MCB Issue List Regarding APR-1400, DCD Tier 2, SECTION 10.4.8

Issue #1 (AI 10-12.1)

Figure 10.4.8-1 Steam Generator Blowdown System Flow Diagram (2 of 2)

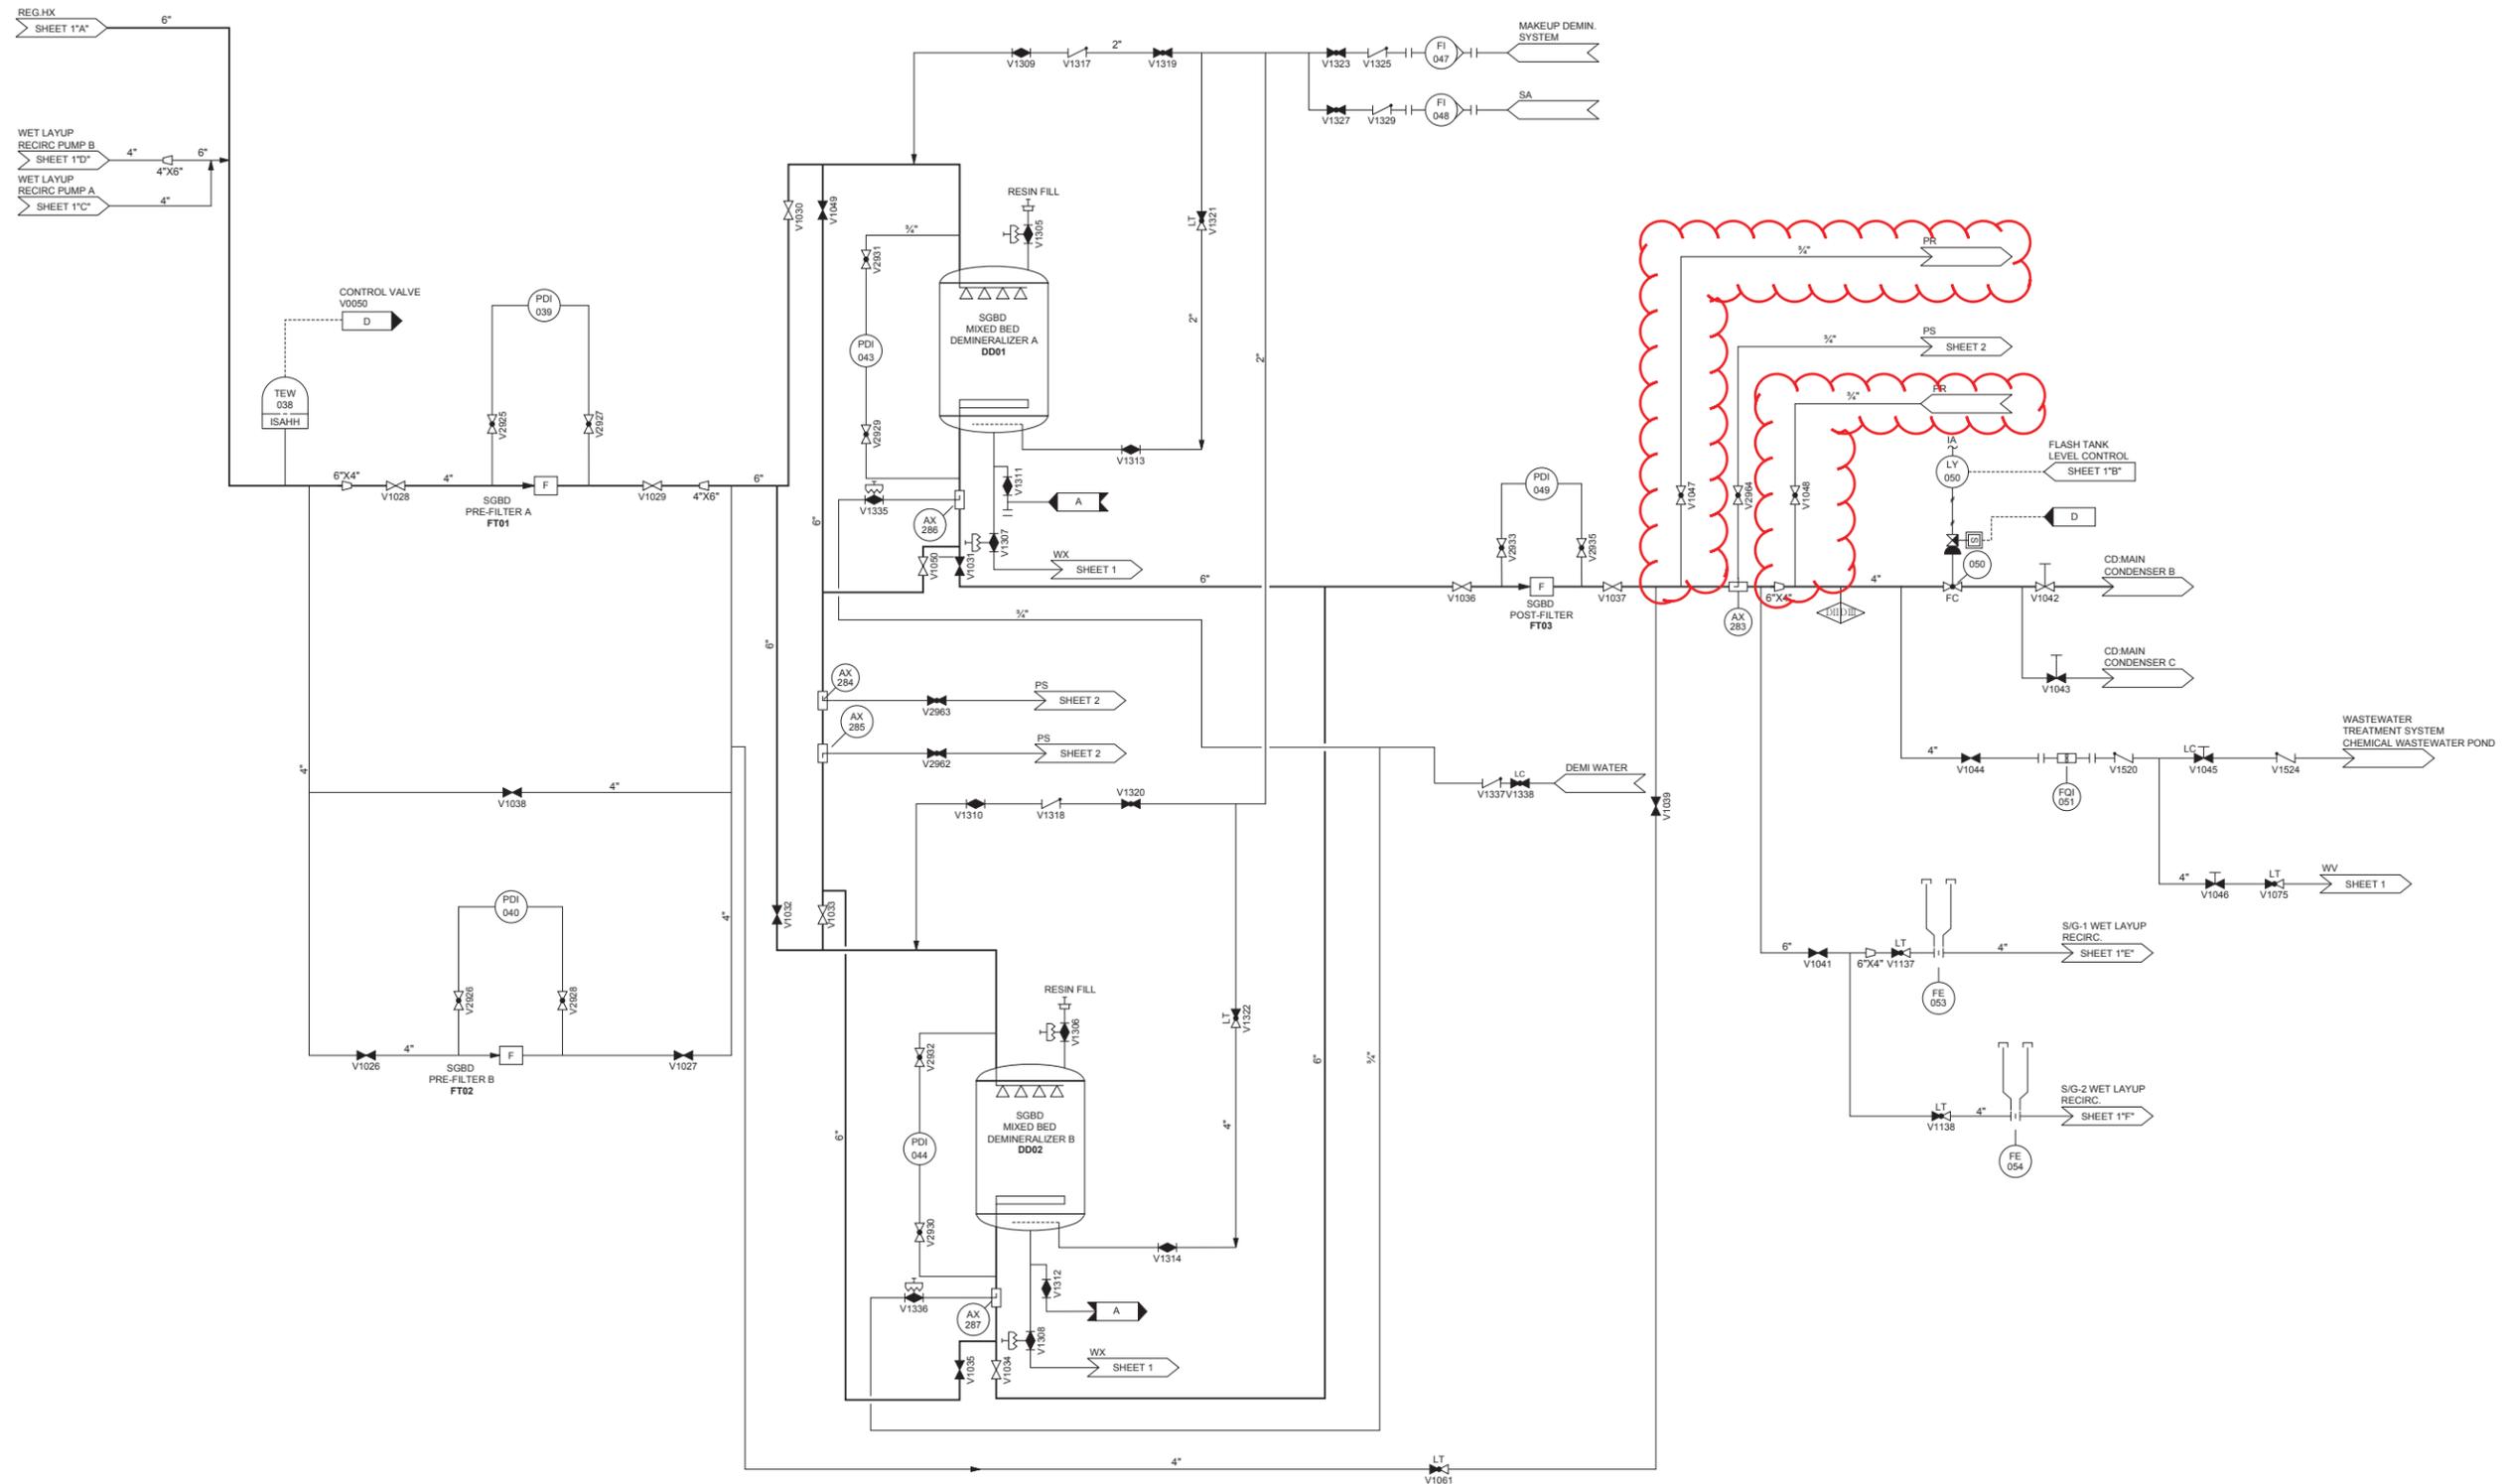
FSAR Subsection 10.4.8.2.3.5, Item c, refers to high radioactivity measured at the SG blowdown demineralizer outlet. The staff was not able to identify a radiation monitor at this location in the figures (FSAR Figure 10.4.8-1).

Revise FSAR Subsection 10.4.8 to provide more information about these measurements, including the designation and location of the radiation monitors.

The designation for the radiation monitor is located in the Figure 10.4.8-1 as shown in the attachment 1. The location of the radiation monitors is described in Subsection 10.4.8.5 as shown in attachment 2.
